Fleetwood Enterprises, Inc.  
Motor Home Division  
Recreational Vehicle Group  
2970 Myers Street, P.O. Box 7638  
Riverside, California 92513-7638  
(909) 351-3800 FAX (909) 351-3986

99-156 (01)

FIRST NOTICE**IMPORTANT RECALL INFORMATION**

## TRAILER HITCH HUCK BOLT REPLACEMENT PROCEDURE

ILLUSTRATION 3

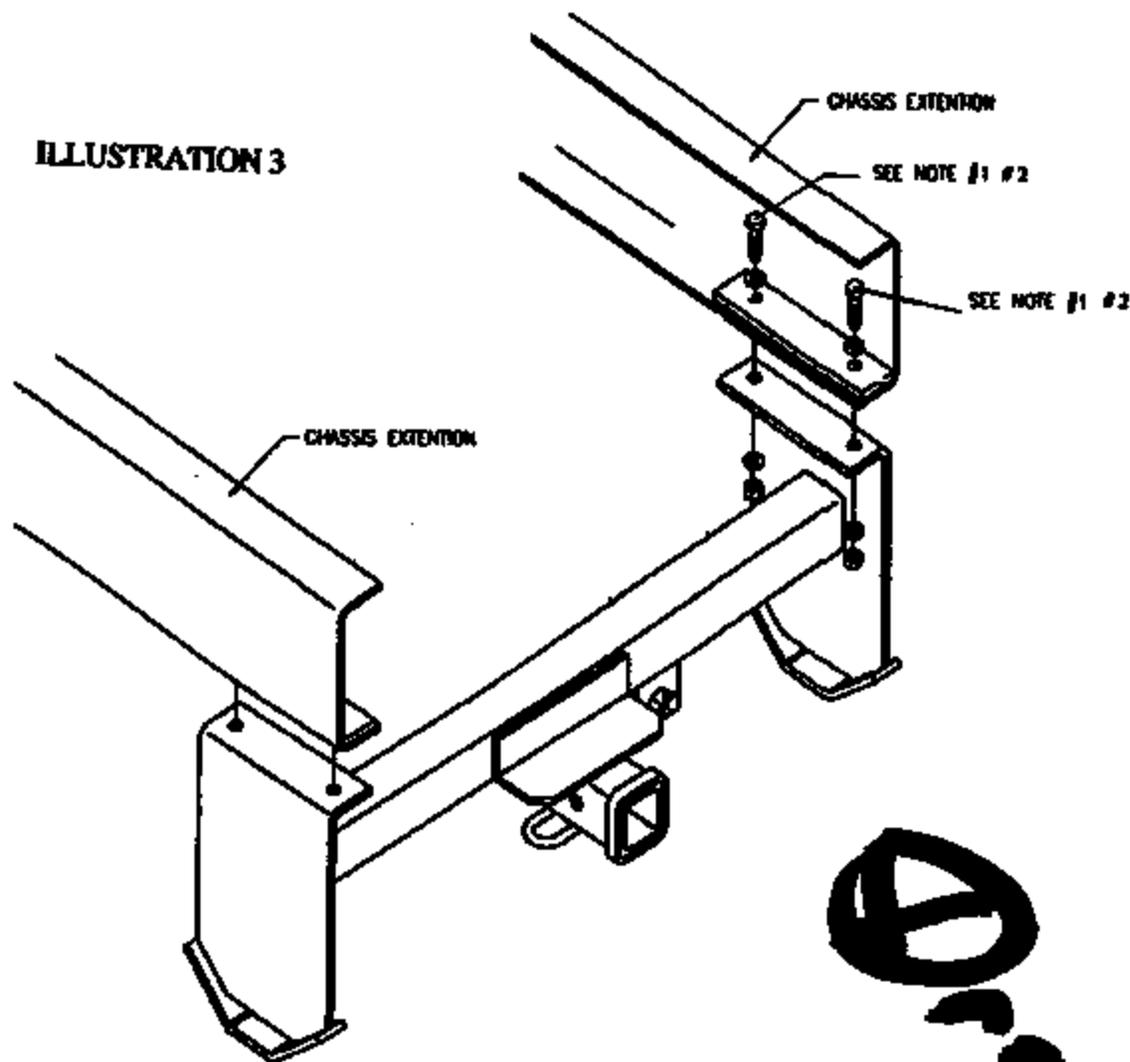
If the huck bolts are not installed per illustration #1, then remove the huck bolts using a cutting torch or a sawsall being careful not to damage the trailer hitch or frame extension by cutting the collar end of the huck bolt off. Then install 4 each  $\frac{1}{2}$ x20x2" bolts per illustration #3.

- NOTES:  
 1: TIGHTEN NUTS TO 85 +/- 5 FT / LBS  
 2: SEE PARTS LIST FOR NUTS AND BOLTS

ILLUSTRATION 2

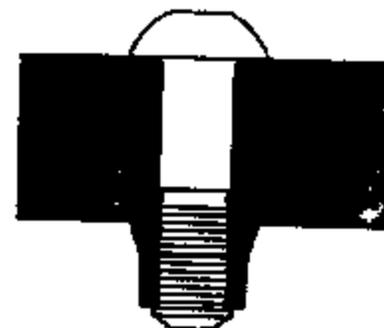
Inspect the trailer hitch huck bolts for the correct grip. (See illustration 1&2).

INCORRECT COLLAR INSTALLATION SHOWN
